**TROON NORTH TRACT V**

**COMMENT RESPONSE**

**CITY OF SCOTTSDALE TRACKING NO: 878-PA-2015**

RE: Troon North Tract V- Comment Response  
City of Scottsdale Reference # 10-PP-2015

## EXHIBIT - 1 EXISTING SITE TOPOGRAPHY

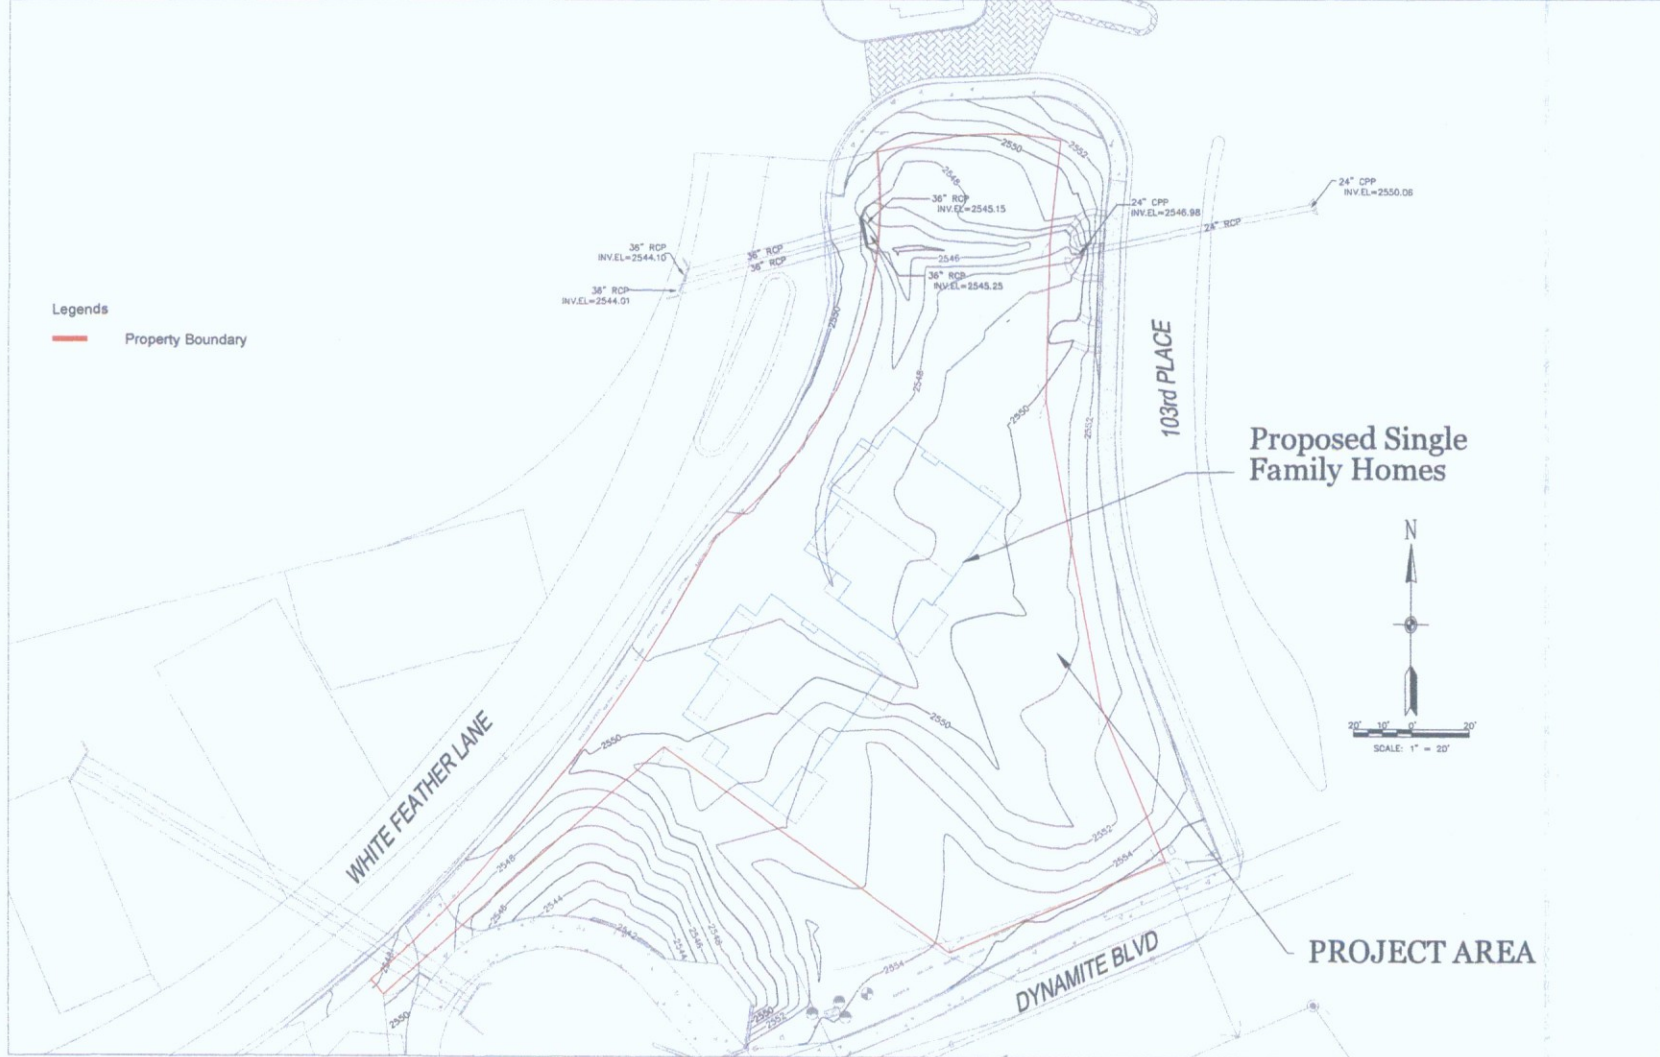
**Comment #7:** *The 24"x36" exhibits which show the existing condition survey topo. Please update the exhibit to identify the upstream and the downstream invert elevations: for the existing 24" pipe culverts located under N. 103<sup>rd</sup> Street, and for the existing 2-36" pipe culvert under E. White Feather Lane, in the XXXX.XX ft. format. Please also identify all Q<sub>100</sub> (from existing approved study or calculated) on the project site on this exhibit. Cite the source of the Q<sub>100</sub> of 122 cfs below the Q<sub>100</sub> value within parenthesis on this exhibit, which is COS Case #: 51-PP-1994 (DSPM Section 4-1.900 & Section 4-1B).*

**Response:** Exhibits are revised to include culvert's inlet and outlet elevation and 100-year offsite flow. Please refer to Exhibit 1, 2 and 5. Source for the offsite flow are discussed in Section 3 of the revised Drainage Report.
